M-9A0 (Calpella + N11P/M Discrete Graphic)

FOXCONN		HON HAI Precision Ind. Co., Ltd.	
		CCPBG - R&D Division	
Title ARD (CLK,MISC,JTAG)			
Size	Document Number	Rev	
Custom	M9A0 MP	1.1	
Date:	Thursday, November 19, 2009	Sheet	3 of 73

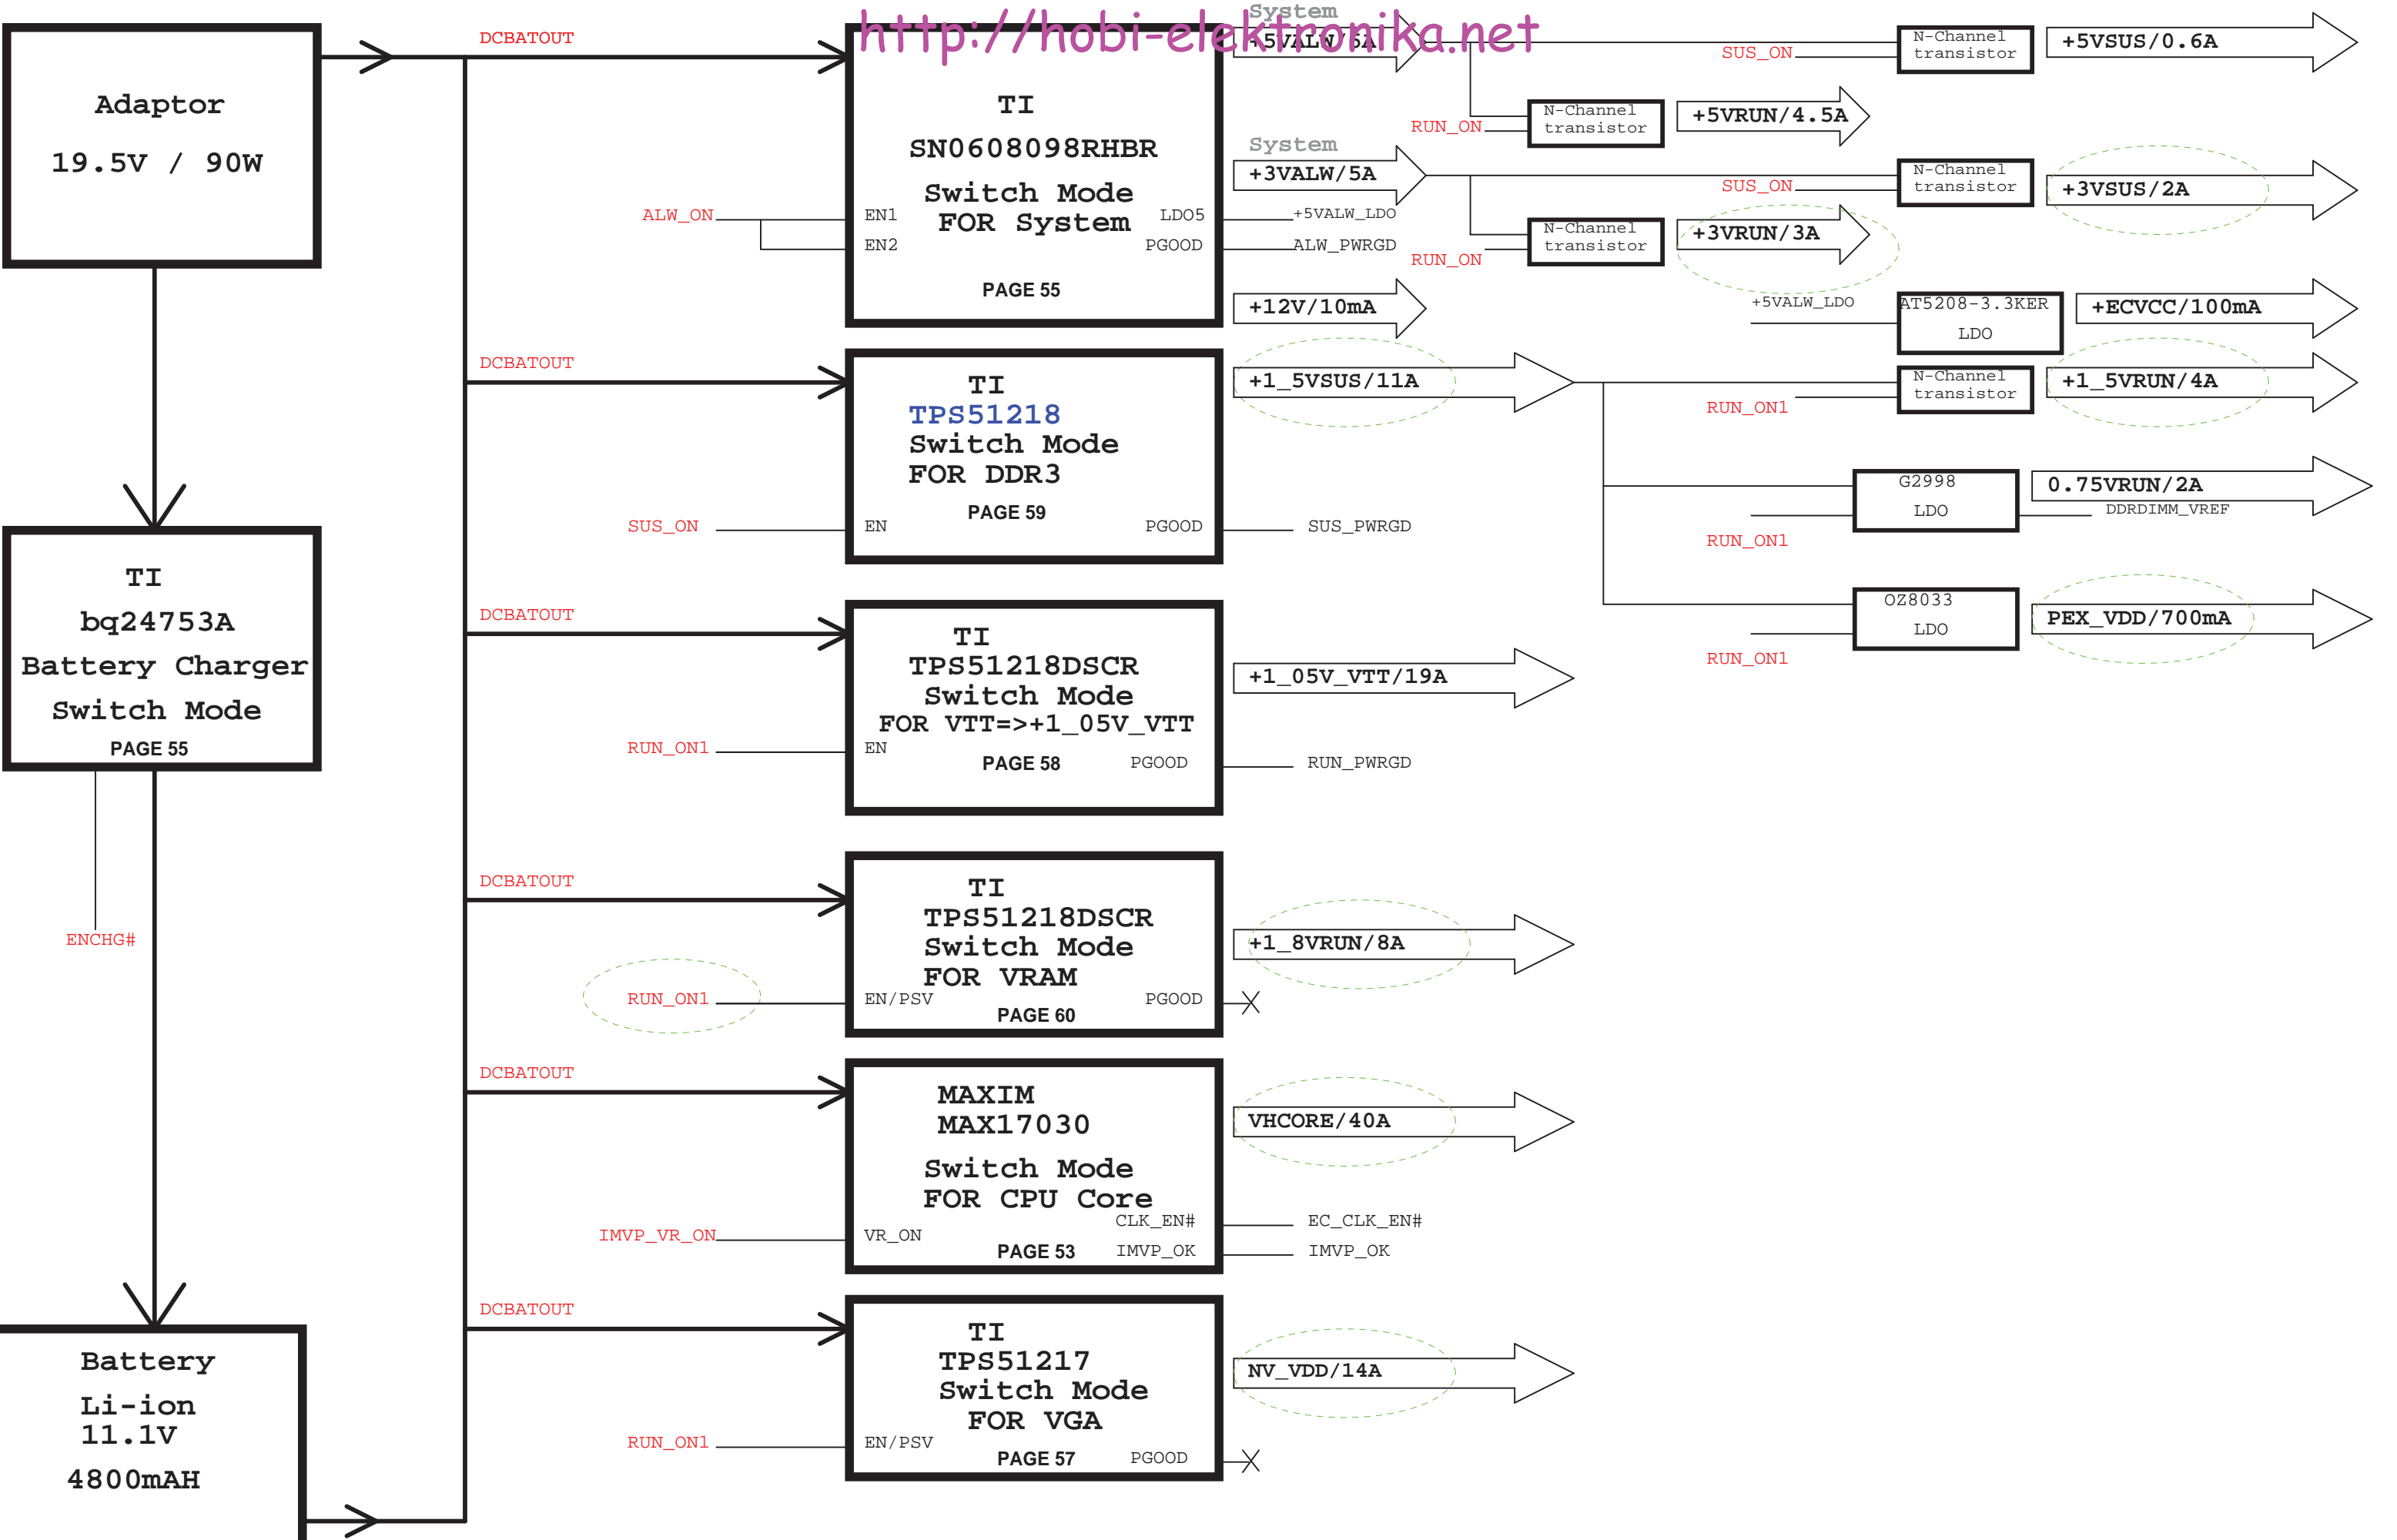
2009.10.30
change R5992,R5993,R5994 from 120ohm to 549ohm follow M870

2009.10.22
change PC112 from 68U to 47U for power request

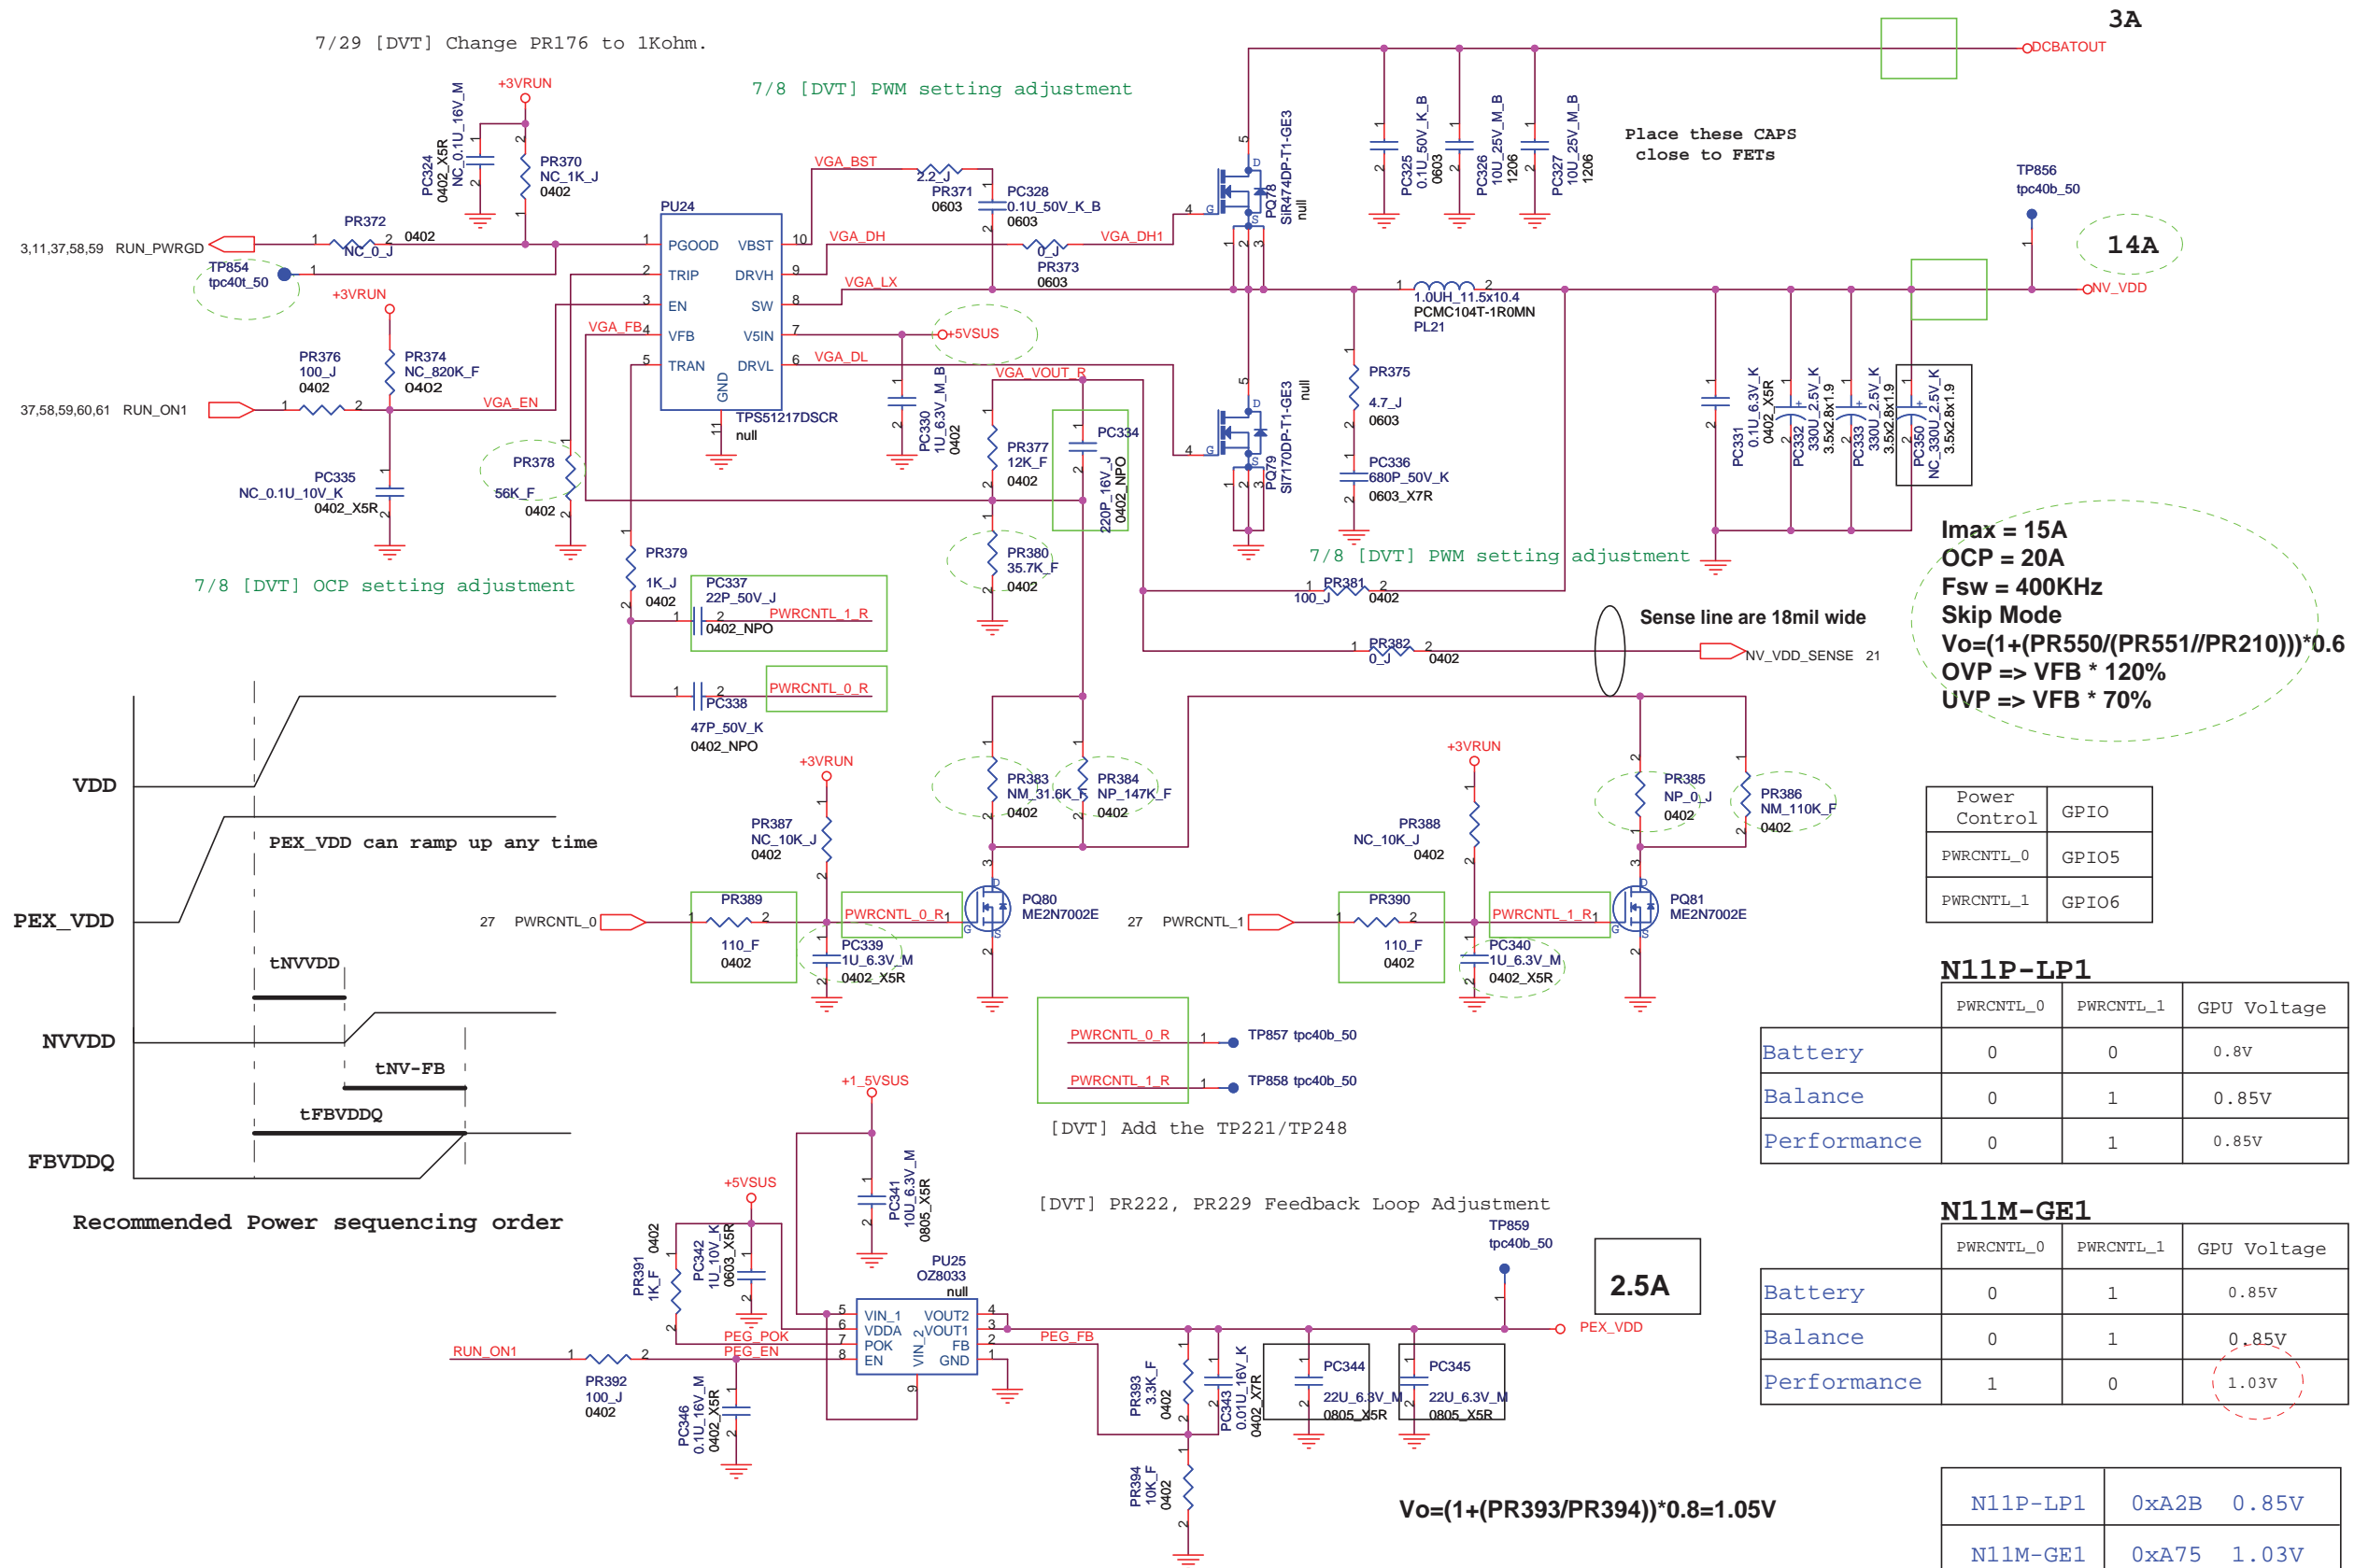
2009.10.19
change PC319 from 1C-2B20104-K301 to 1C-2B20104-K300 for PVT
